DATE	July 2023 rev1
PRODUCT	HIKVISION TWO-WIRE INTERCOMS
SUBJECT	Mixing Y-Series components with legacy components
DETAIL	Current Hikvision Y-Series two-wire intercoms are not compatible with previous series (which are no longer available). This solution provides a method for expanding existing installations by mixing old and new components.
REMEDY	Add a network switch as a communications bridge between 104-222 KAD706 and 114-656 KAD706Y

EXAMPLE.

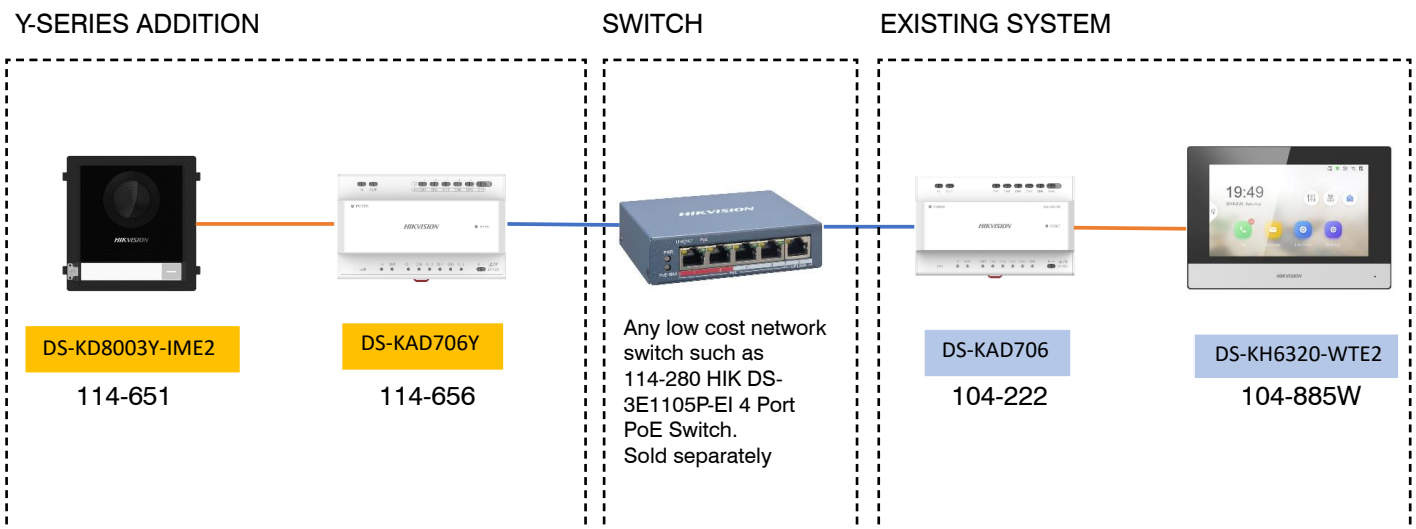
Adding a new Y-Series door station to an existing two-wire system.
